# UNITED STATES PATENT AND TRADEMARK OFFICE

# Office Action Summary

09/662,209

ACKLIN ET AL.

**FIG. 1**

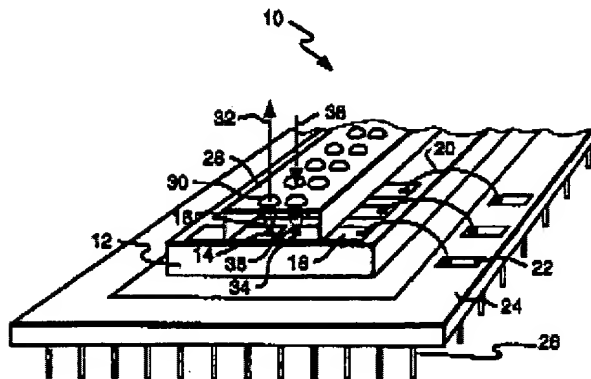
Figure 1 illustrates an array of lasers having an optoelectronic chip (12) where the array of lasers are carried, an optical chip (28), which covers the array of lasers with an optical element (30) where the laser beam emits. A wire bond (20) electrically connects the laser to a terminal pin (26). Pins (26) are connected through macroscopic package (24) where optical chip is mounted.

Figure 1 illustrates an array of lasers having an optoelectronic chip (12) where the array of lasers are carried, an optical chip (28), which covers the array of lasers with an optical element (30) where the laser beam emits. A wire bond (20) electrically connects the laser to a terminal pin (26). Pins (26) are connected through macroscopic package (24) where optical chip is mounted.

**FIG. 5**

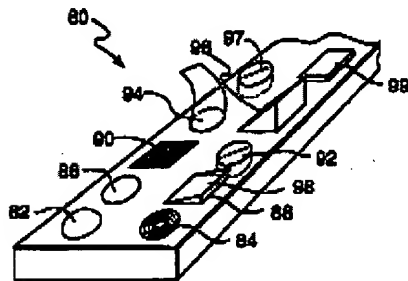
Figure 5 illustrates an optical chip (80) having optical elements, which may be used in place of optical chip (28), as disclosed in column 8 lines 23-49.

Figure 5 illustrates an optical chip (80) having optical elements, which may be used in place of optical chip (28), as disclosed in column 8 lines 23-49.

U.S. Patent Jul. 10, 2001 Sheet 9 of 14 US 6,259,713 B1

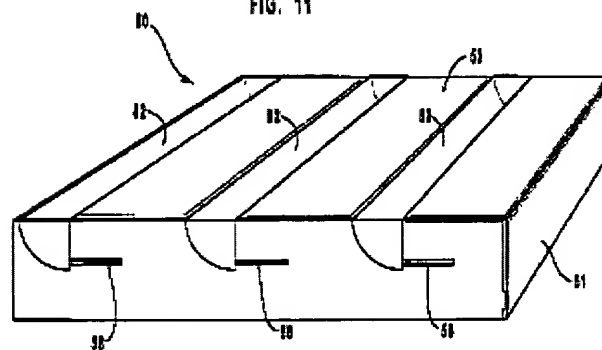
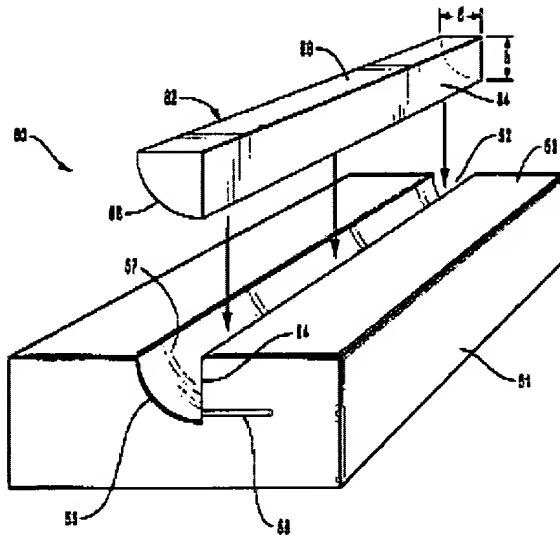
Hwu et al illustrates in figures 11 and 12 a ceramic substrates having a recess within the substrate and having a mirrored surface on the ceramic substrate where a transparent optical element is placed within the recess which includes the mirrored surface to reflect the laser beams of the diode laser array towards a transparent flat surface which covers the entire recess. In column 11 lines 18-25 discloses using ceramic substrates are highly thermally conductive.

**F I G. 1**

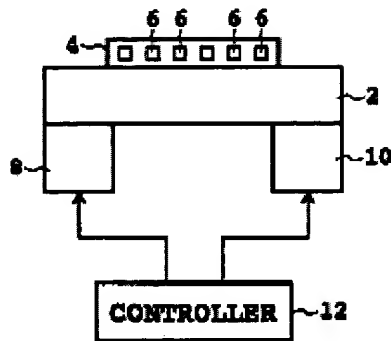
The use of Peltier elements to provide cooling or temperature control to the substrates of laser system is well known in the laser art as shown in figure 1.
